**Comments of the Natural Resources Defense Council and Sierra Club on the
California Energy Demand 2014 – 2024 Final Forecast
CEC 2013 Integrated Energy Policy Report, 13-IEP-1C**

December 10, 2013

Submitted by: Sierra Martinez (NRDC), Maria Stamas (NRDC), and Matt Vespa
(Sierra Club)

Figure 1: Underestimating Energy Savings Risks Over-Procurement of Power Plants in IOU Service Territories²³

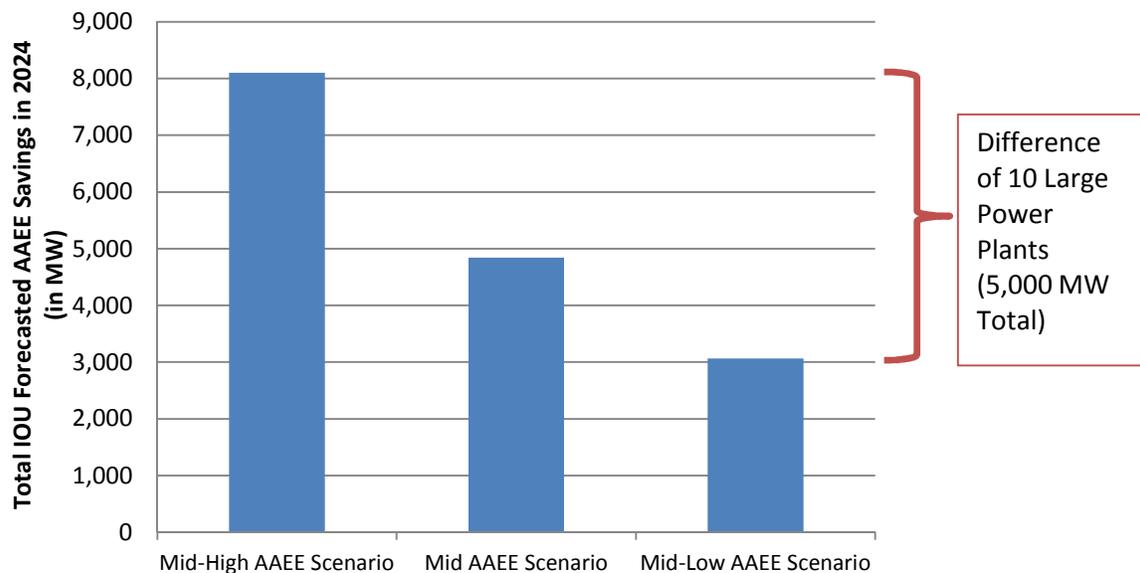
As shown in Figure 1, the difference of estimated needs among the investor-owned utilities due to the differences in the CEC’s various AAEE scenarios could be the equivalent of ten large power plants (500 MW each). I.e., using the “Low-Mid” AAEE Scenario (which is effectively just a “Low” AAEE Scenario) instead of the Mid AAEE Scenario creates about 4 large power plants (2,000 MW) worth of additional demand, and about 10 power plants (5,000 MW) worth of additional demand compared to using the Mid-High AAEE Scenario. Additionally, as explained in Section II.7, the CEC omits about 1,300 MW of POU energy efficiency savings over the next ten years. The scenarios have significant variations and the POU omission is an egregious omission, both of which greatly increase the risk of overprocurement of power plants. Therefore, it is critical that the Energy Commission select at least the Mid AAEE Scenario (which is already conservative) to be paired with the Mid baseline forecast in order to avoid the risk of building unnecessary power plants in California.

Figure 2: Projected Energy Savings From 2013 POU Programs-Mid Demand Case in Cumulative GWh²⁶

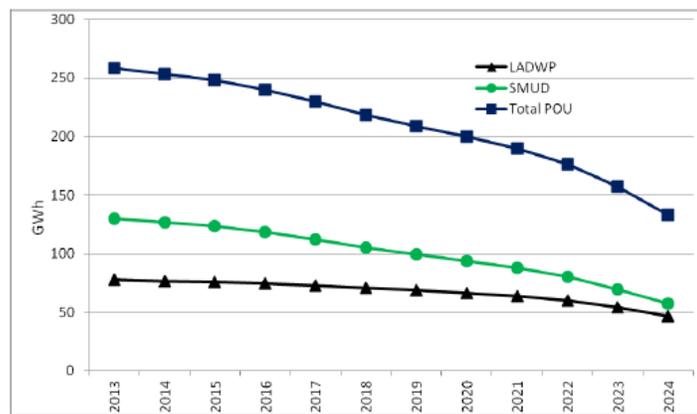
We strongly recommend the Commission include Additional Achievable Energy Efficiency savings from publicly-owned utility programs. Specifically, the Mid Savings Scenario should be changed to include the POU's ten-year targets, which are reasonably expected to occur. Currently, the CEC Mid Savings Scenario excludes the vast majority of savings from future POU efficiency programs, including only one out of ten years' worth of program savings.²⁵ The CEC assumes that POU energy efficiency programs stop after 2013, which is clearly wrong. Using the CEC's assumptions about POU efficiency programs stopping after 2013 significantly distorts and reduces future energy savings from the POU's, see Figure 2.

Forecast projects less than 150 GWh over the next ten years, see Figure 2. Including savings from only one year of a ten-year long period is unreasonably low. Furthermore, the 150 GWh projection is not commensurate with historical POU achievements, which yielded about 440 GWh in 2012 alone, and over 2,000 GWh over the past seven years.²⁸ It is critical that the CEC include reasonable estimates, and for the full ten years of future POU program energy savings, in the Mid Savings Scenario of Additional Achievable Energy Efficiency savings estimates.

Figure 3: POU Annual Energy Savings Targets, 2014-2023 in Annual MWh²⁹

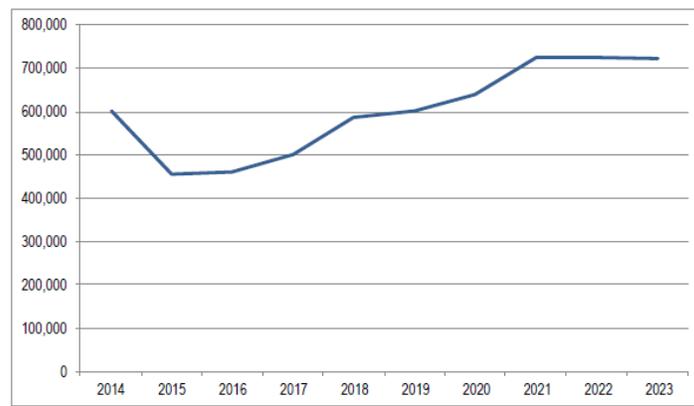
In reality, robust long-term energy efficiency potential studies demonstrate that energy efficiency programs will continue beyond 2013. Not only are POU programs projected to provide savings in years beyond 2013, but in the long run, these *annual* savings even increase. The results of these potential and goals studies were submitted to the CEC in March 2013. The studies project over 4,000 GWh and 1,300 MW²⁷ of savings from efficiency programs over the next ten years, see Figure 3. Whereas the Final
